Your Ref: SSD-67924472
Our Ref: LTR009-01-20-795 A Lot 3 MOD1 Civil Statement

RE: Light Horse Business Hub – SSD- 67924472 MOD1 – Civil Design Statement

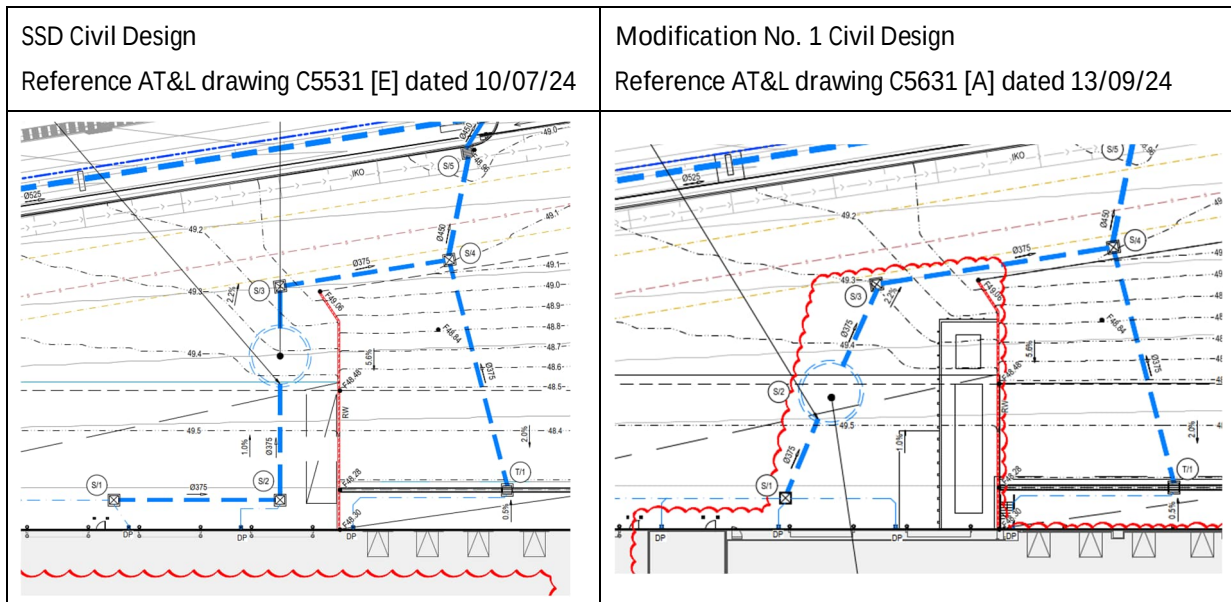
The Site Plan changes are nearly all related to internal building changes (office fit-out, internal warehouse use), and therefore the affects to the external civil works are negligible. The only change of note that affects the civil design relates to the introduction of an external refrigeration plant area, within the hardstand of Warehouse 3B. As a result, a minor adjustment to the location of inground stormwater has occurred in this location. A comparison of the approved civil design and the revised civil design per Modification No. 1 are shown below for comparative purposes, with the areas changed clouded for clarity.

AT&L can confirm that the adjustments made to the civil design with respect to Modification No. 1 have had a negligible effect to the civil design itself, and as such, the discussions included within AT&L's aforementioned Civil Report remain applicable and true for the revised civil design prepared for Modification No. 1.
